September 15, 2017

RE: Comments of the Environmental Integrity Project, et al., Regarding MarkWest's Application to Construct and Operate the Harmon Creek Gas Plant Under GP5, GP1, Permits GP5-63-01011A, GP1-63-01011A, and Request for Determination

Figure 2. MarkWest Natural Gas Facilities in Northcentral Washington County

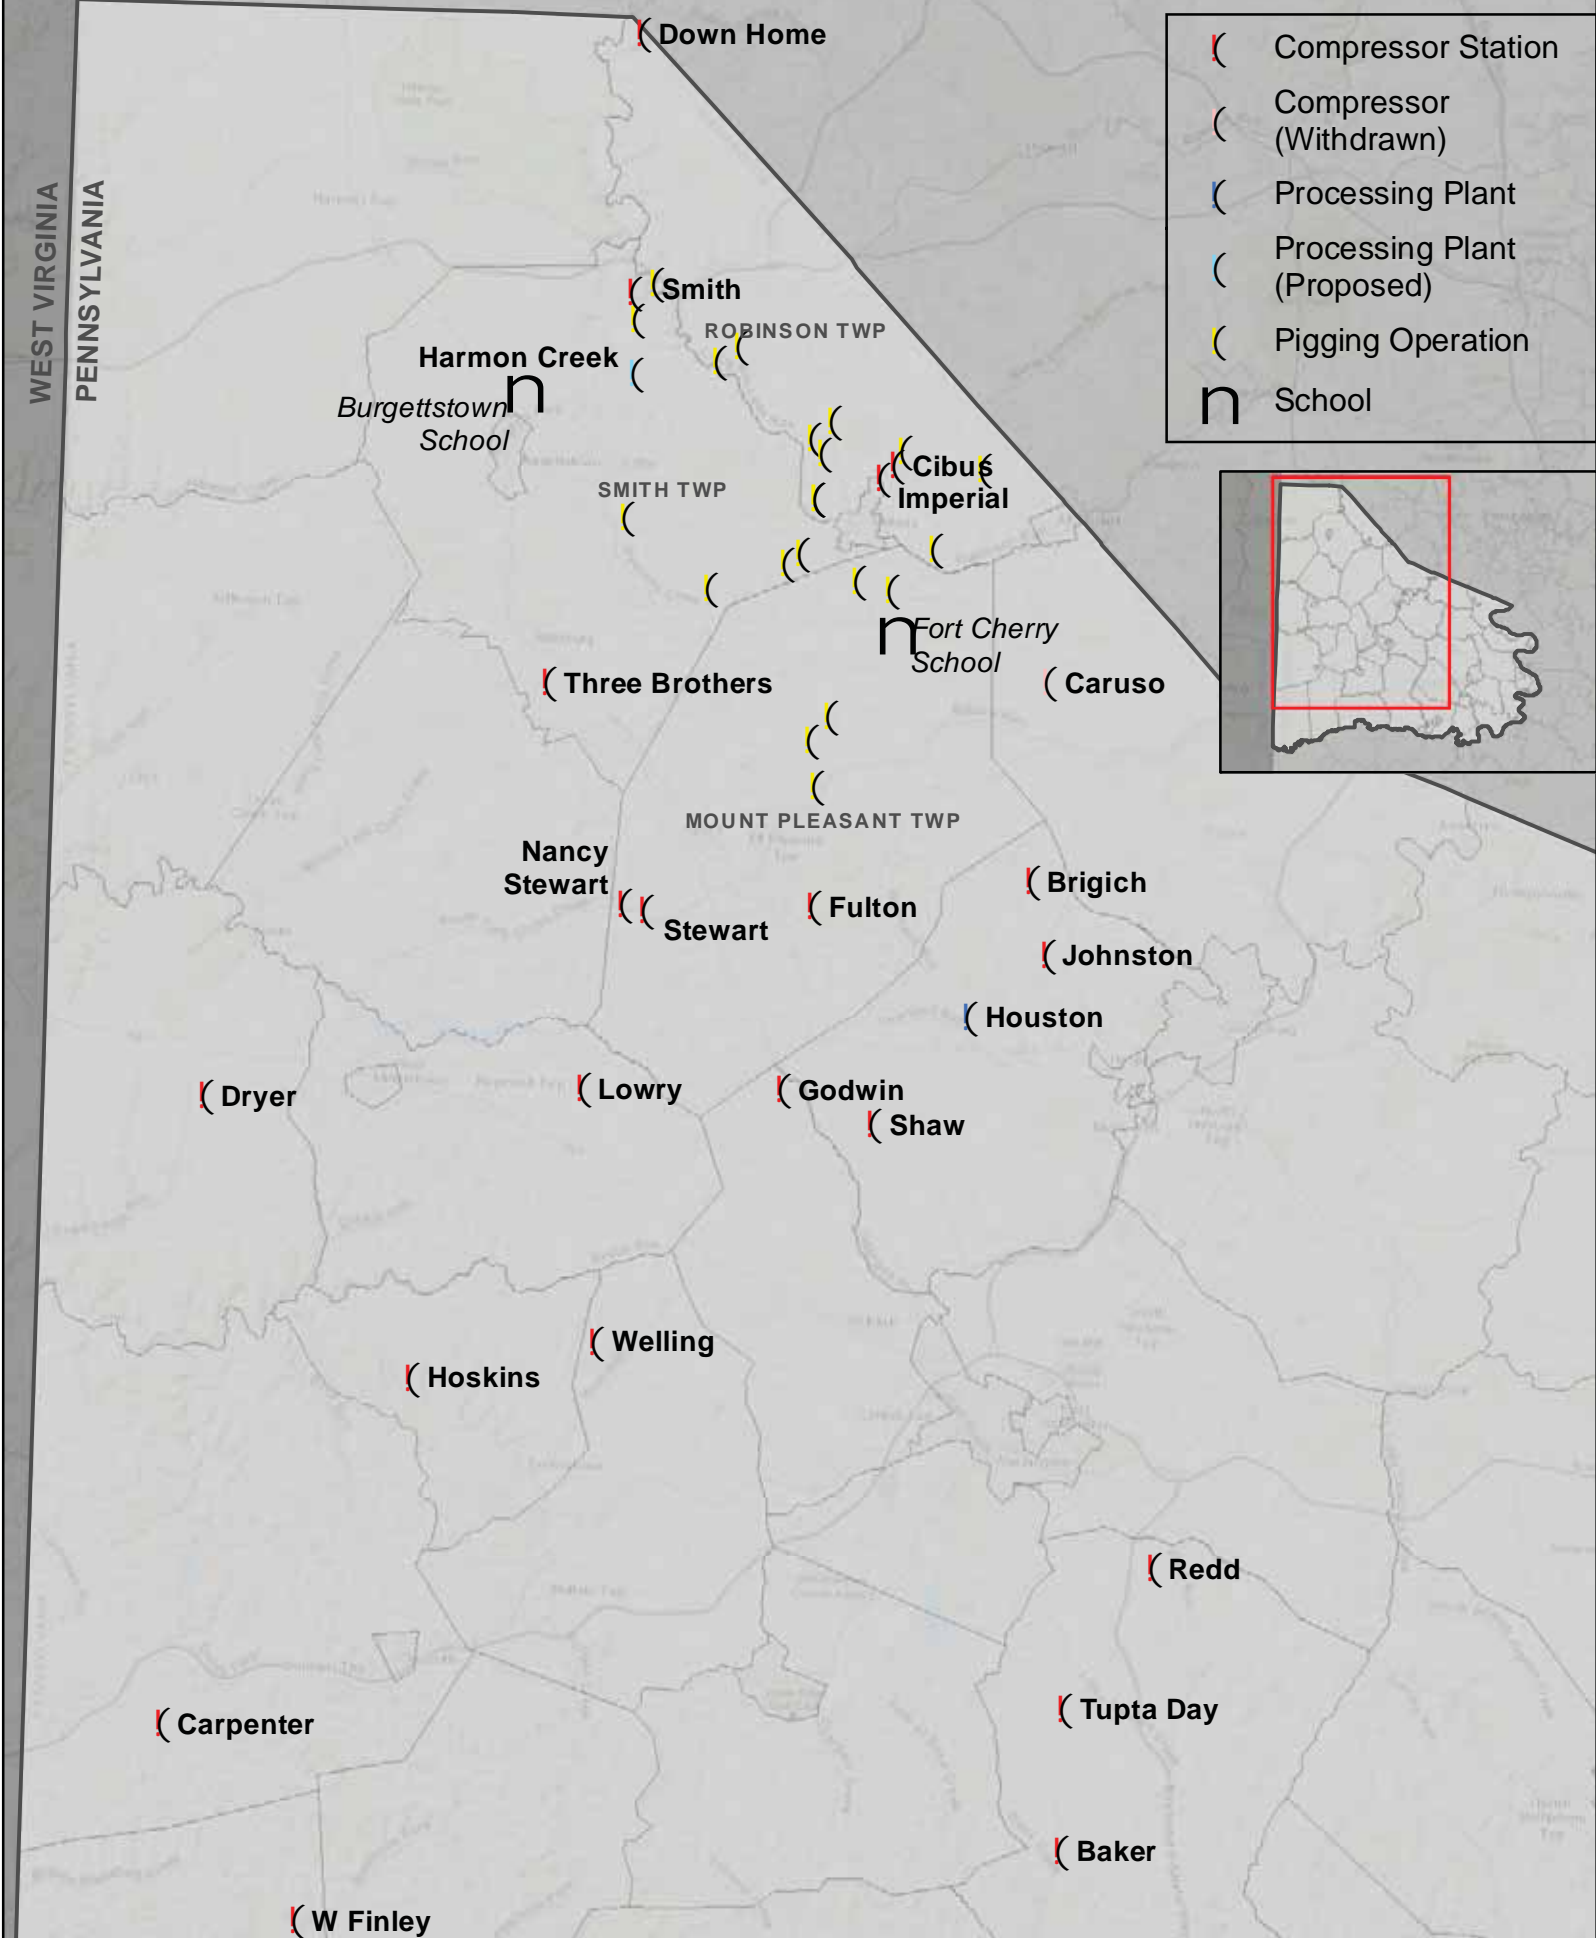
MarkWest did not provide detailed information regarding whether the Harmon Creek Plant’s emissions should be aggregated with any other sources, but aggregation may be appropriate given the high density of MarkWest natural gas facilities in and around Smith Township, Washington County.

Figure 2 was created by EIP for submission with its comments on the draft GP-5/GP-5A permit and shows MarkWest facilities that EIP was able to accurately identify prior to June 5, 2017. Commenters would like PADEP to confirm and provide a detailed analysis of all facilities that it reviewed for potential aggregation with the Harmon Creek Plant. This includes, specifically, the nearby Smith Compressor station. The high density of emissions sources from MarkWest facilities in this region of Washington County is extremely troublesome for local residents and it is imperative that emissions from nearby facilities are subject to aggregation wherever applicable in order to best protect nearby residents. In addition, the question of deliberate circumvention of Clean Air Act requirements discussed above applies to aggregation, raising legal concerns.
